RE: Amendments to Chestnut Street Lofts
CBL: 21 - C - lots 1, 10 and 11

On May 31, 2007, the Portland Planning Authority approved the amendments to the Chestnut Street Lofts site plan as shown on the approved plans¹. The approved revisions include changes to the court yard, granite topped benches within two arches along Chestnut Street, a solid wall along Chestnut Street, and a lower retainer wall along the rear property line. The submitted plan includes elimination of the planters along Chestnut Street, but the applicant has withdrawn this request and has installed the planters according to the original approved plan. Copies of the approved plans are attached with a note that the planters are to be installed.

CHESTNUT STREET LOFTS
URBAN REVITALIZATION PROJECT
BY CHESTNUT STREET LLC.
PORTLAND, MAINE

SK-R-3
REVISION

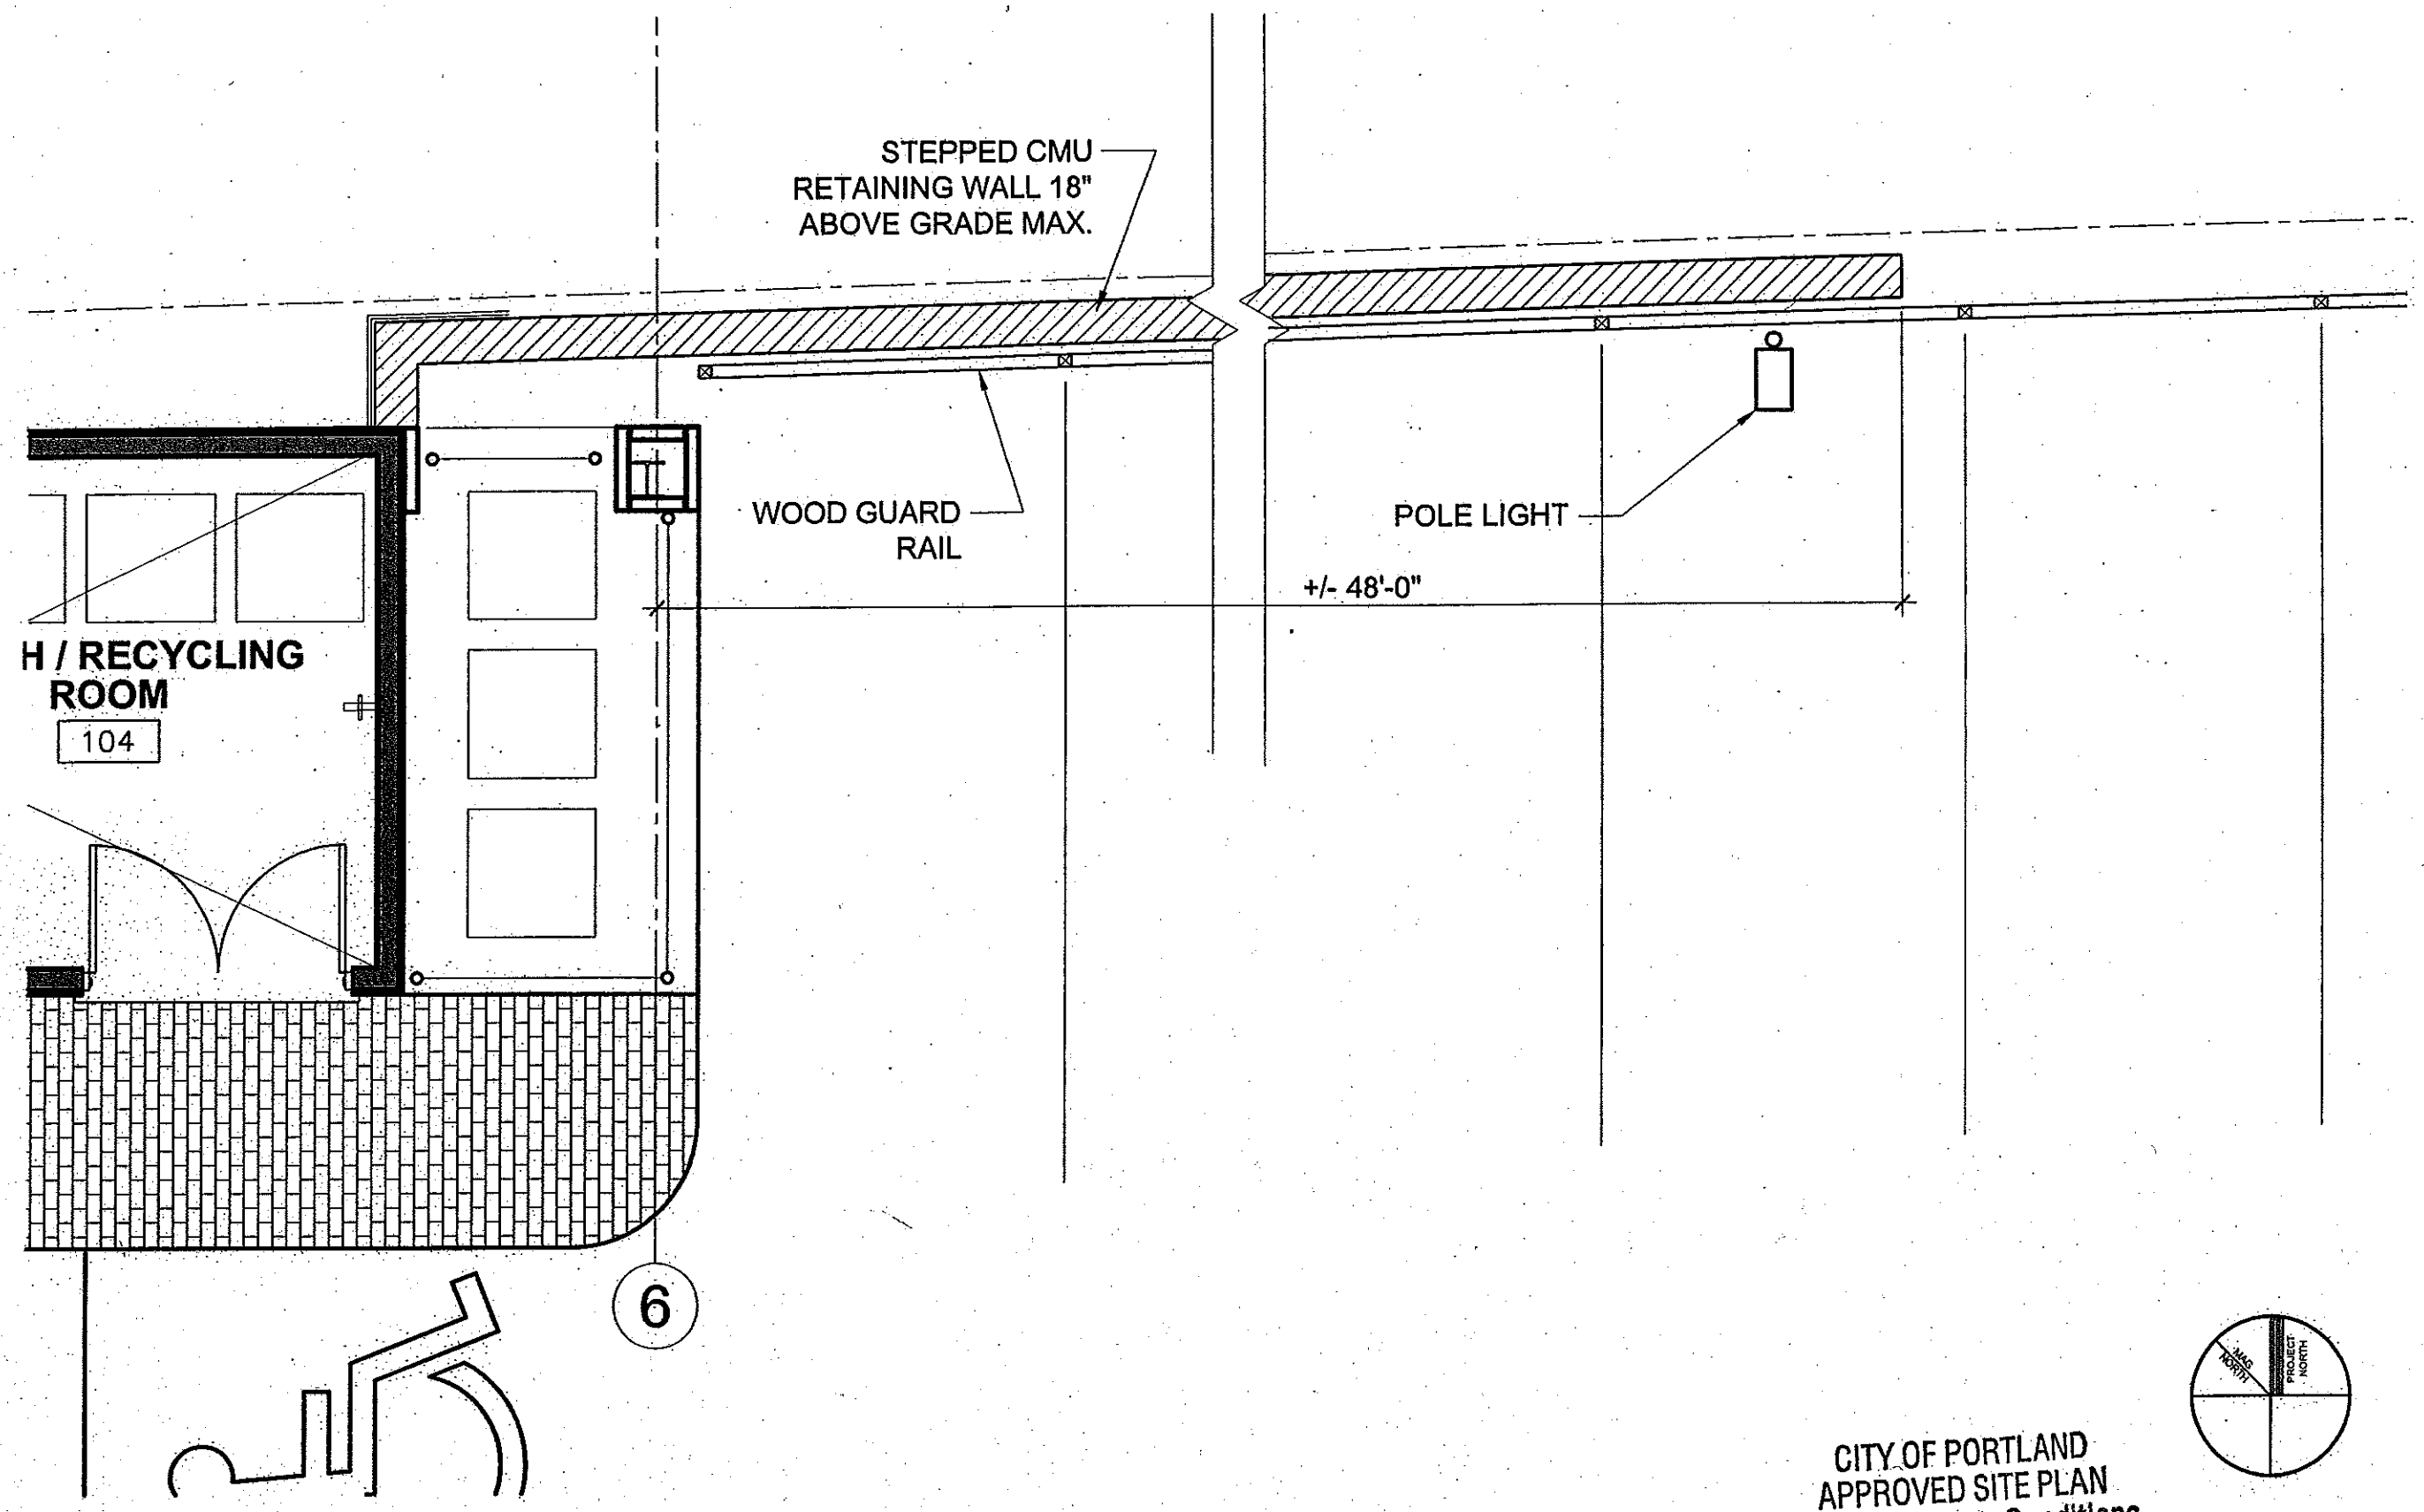
ELIMINATE CURVED
GRANITE PLANTER
SOLID MASONRY
INFILL WALL

SK-R-4
REVISION

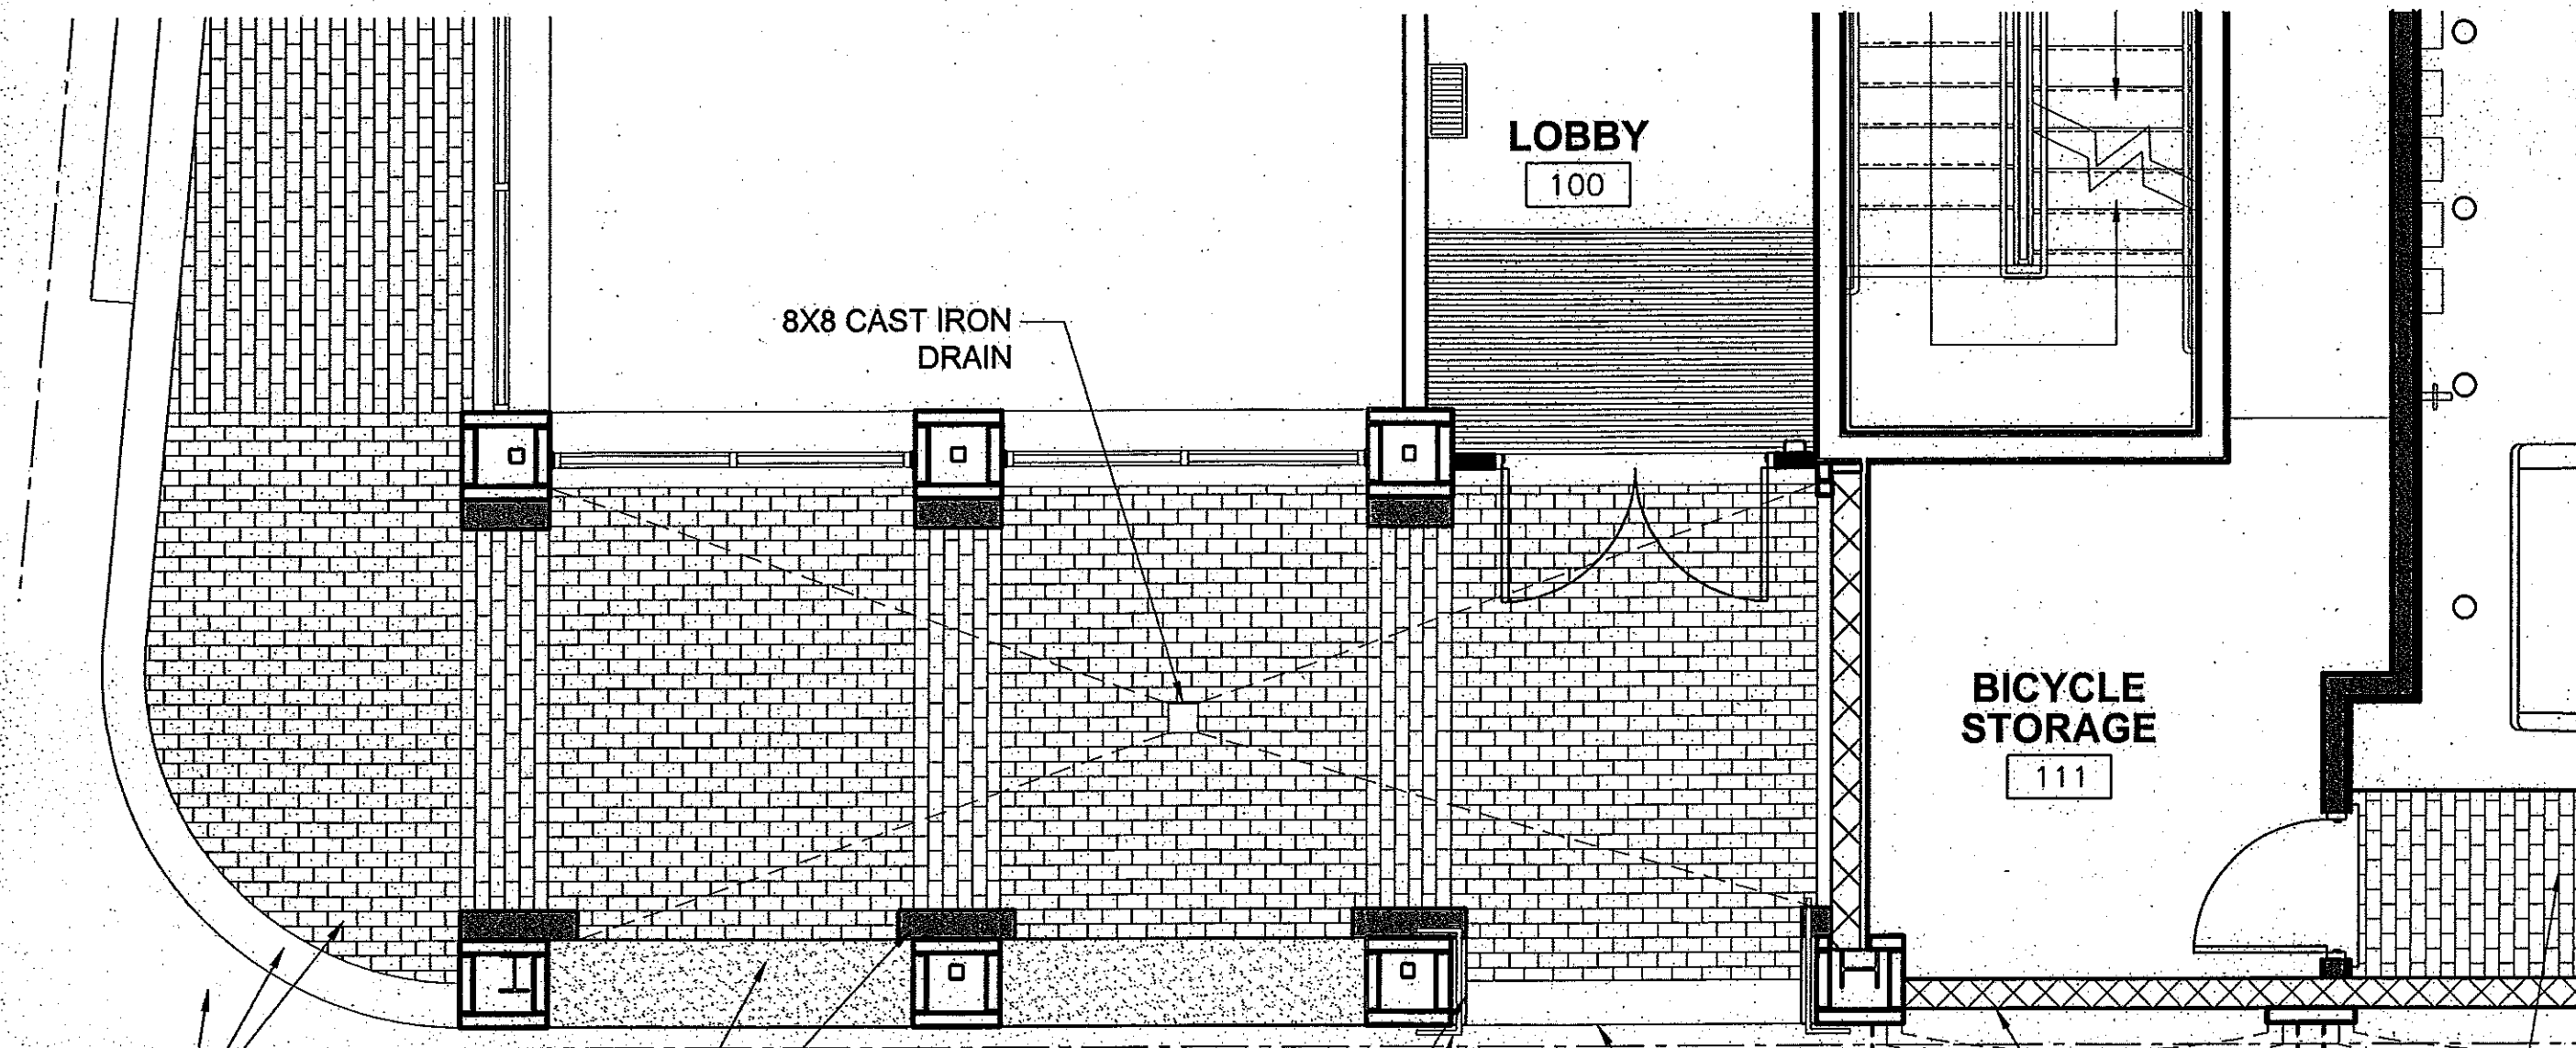
ELIMINATE CURVED
GRANITE PLANTER

SOLID MASONRY
INFILL WALL

No ~~to~~ this
note ~~to~~
planters to
be installed according
to original
approved plan
B. Barhydt
